DEVELOPMENT REVIEW COMMITTEE (DRC) COMMENT REPORT

PROJECT NAME: Estel Plaza/West Broward Retail Plaza

CASE NUMBER: PLN-SITE-20030010

REQUEST: Site Plan Level II Review: 2,992 Square Foot Retail Use,
2,131 Square Foot Restaurant Use with 398 Square Foot
of Outdoor Dining Use

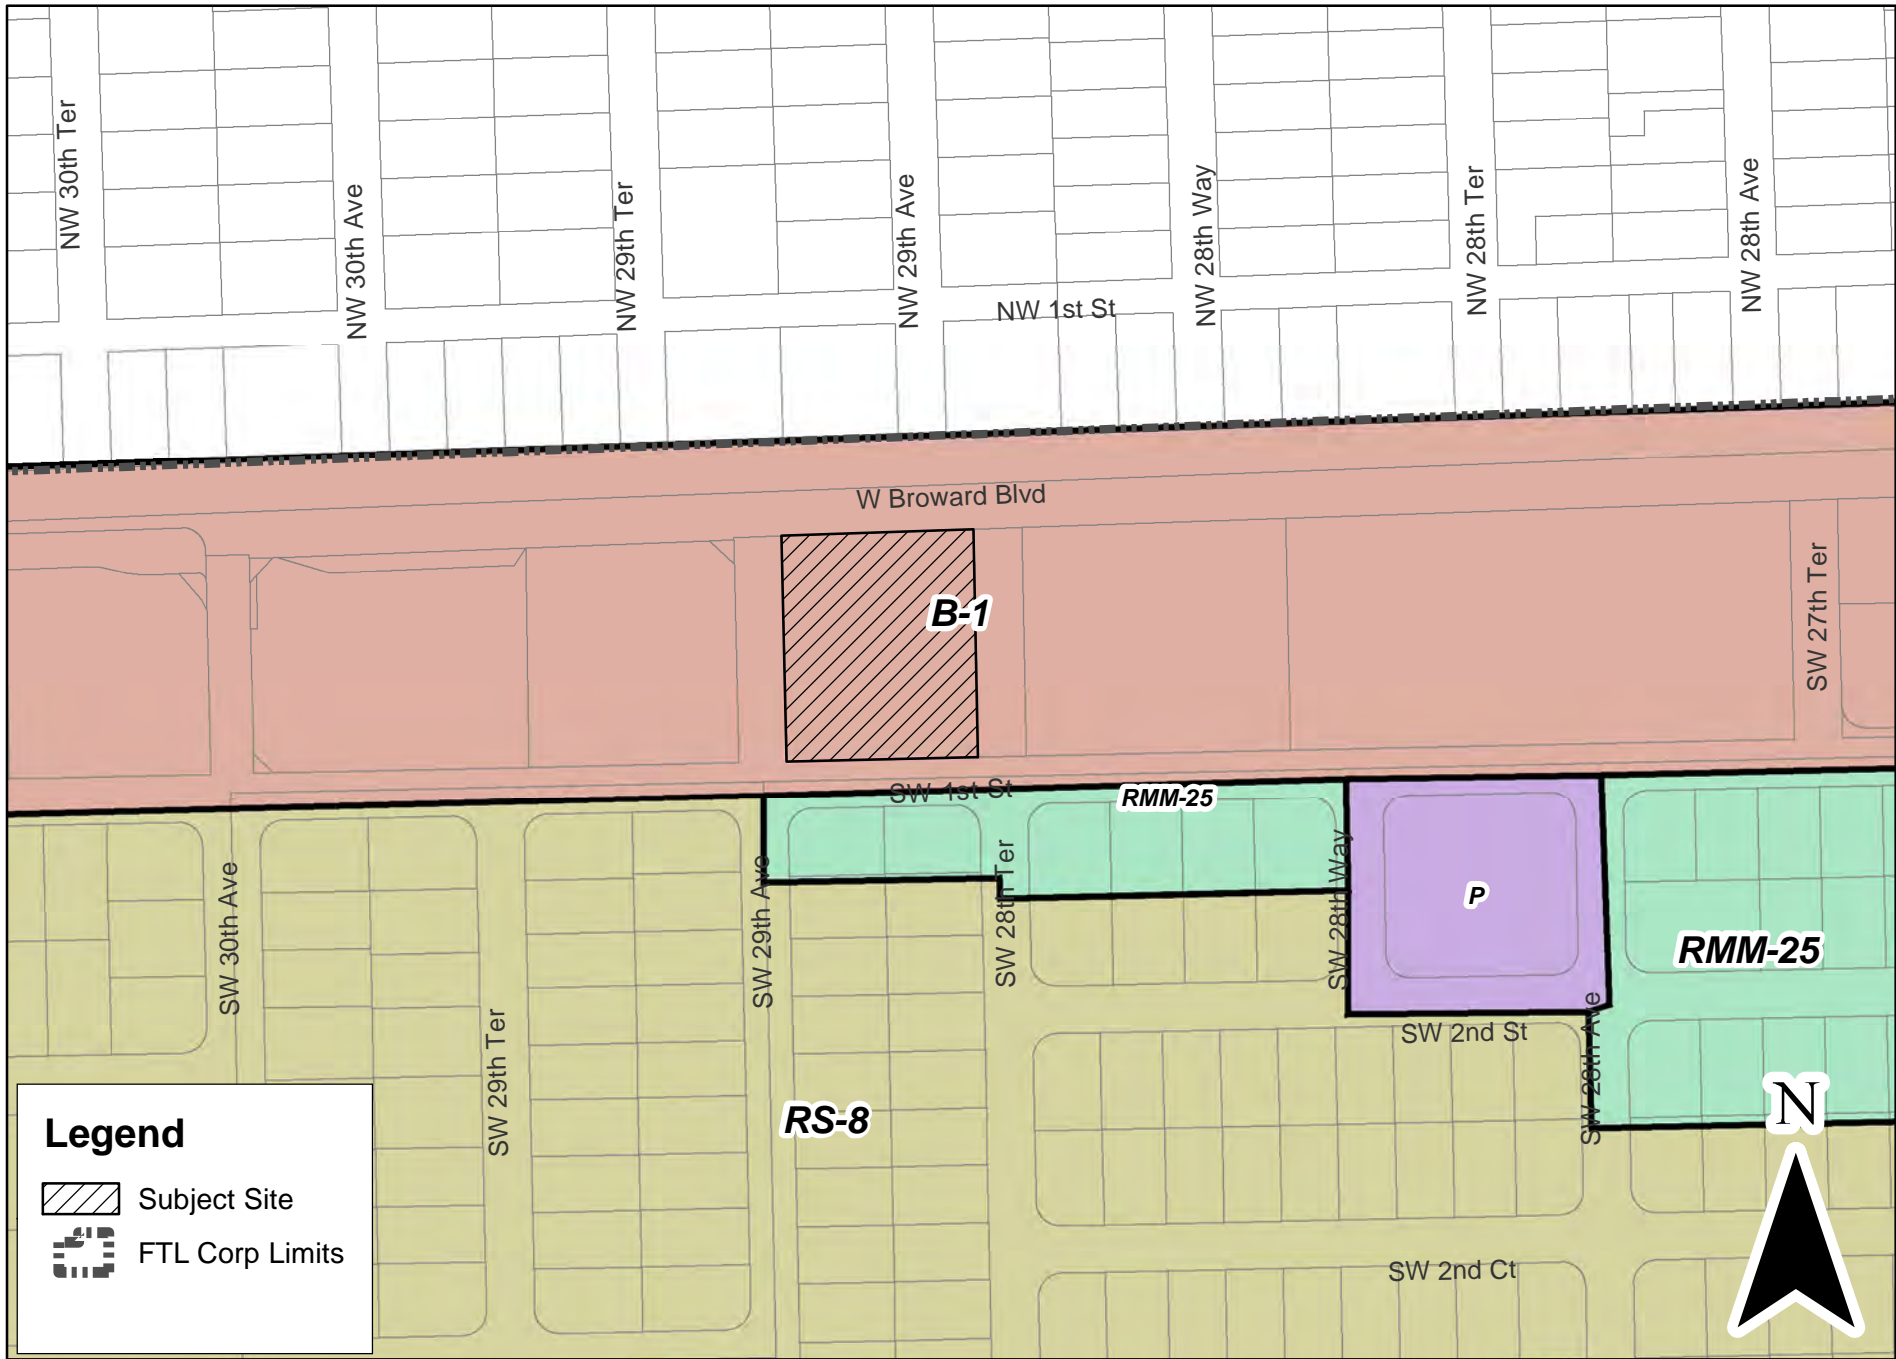
- 1) The applicant is strongly encouraged to contact neighbors adjacent to, as well as condominium and neighborhood associations located within three hundred feet (300') of the development site, to advise of this proposal (a listing of officially-recognized associations is provided on the City's website: www.fortlauderdale.gov/neighbors/civic-associations and a map of neighborhood associations may be found at: <http://gis.fortlauderdale.gov>). Please provide acknowledgement and/or documentation of any public outreach.

- 2) The site is designated Commercial on the City's Future Land Use Map. The proposed use is permitted in this designation. This is not a determination on consistency with Comprehensive Plan Goals, Objectives and Policies.

- 3) Provide a Plat Determination Letter from Broward County Planning Council verifying whether the property needs to be platted or re-platted. If a plat or re-plat is not required, contact the Broward County, Development Management and Environmental Review Section, at (954) 357-8695 to ensure that the proposed project is consistent with the latest recorded plat restriction(s). If a plat note or non-vehicular access line (NVAL) amendment is needed, a separate application is required, which is reviewed administratively and can be found here: Administrative Review Application

- 4) Provide the following changes on the site plans:
 - a. Update plans to provide a 7' sidewalks along S.W. 1st Street and SW 29th Avenue. Dimension all existing and proposed sidewalks.
